**First Meeting of the APIRG Performance Based Navigation/Global
Navigation Satellite System Task Force (PBN/GNSS TF/1)
(Nairobi, Kenya, 12 - 14 October 2010)**

PROPOSALS FOR THE AMENDMENT OF ANNEX 10, VOLUME I, CONCERNING GBAS

Ref.: AN 7/1.3.97-10/43

Subject: Proposals for the amendment of Annex 10, Volume I, concerning the global navigation satellite system (GNSS) ground-based augmentation system (GBAS)

Figure B-19. Example data modulation

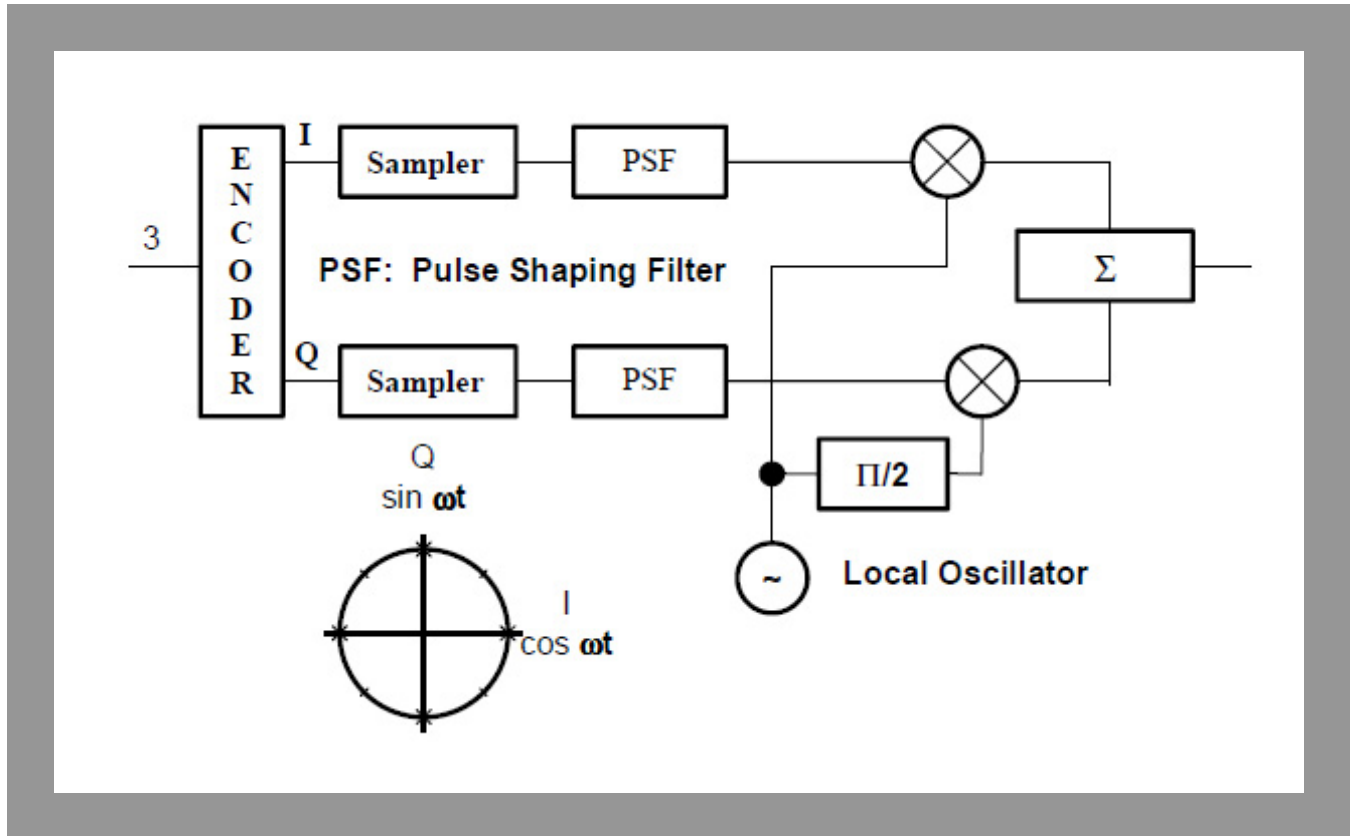
3.6.2.2 *Bit-to-phase-change encoding.* GBAS messages shall be assembled into symbols, each consisting of 3 consecutive message bits. The end of the message shall be padded by 1 or 2 fill bits if necessary to form the last 3-bit symbol of the message. Symbols shall be converted to D8PSK carrier phase shifts ($\Delta\phi_k$) in accordance with Table B-58.

Note.— The carrier phase for the k^{th} symbol (ϕ_k) is given by: $\phi_k = \phi_{k-1} + \Delta\phi_k$. The D8PSK signal may be produced as shown in Figure B-19 by combining two quadrature RF signals which are independently suppressed-carrier amplitude-modulated by base band filtered impulses. A positive increase in $\Delta\phi_k$ represents a counter clockwise rotation in the complex I-Q plane of Figure B-19.

Insert, after Figure B-18, the following new figure:

3.6.2.2, Figure B-19	The current definition of the GBAS digital modulation scheme is ambiguous. The ambiguity was revealed by interoperability testing between two independent implementations of the Standard which resulted in incompatibility because of different interpretations of the Standard. The proposed change resolves the ambiguity.
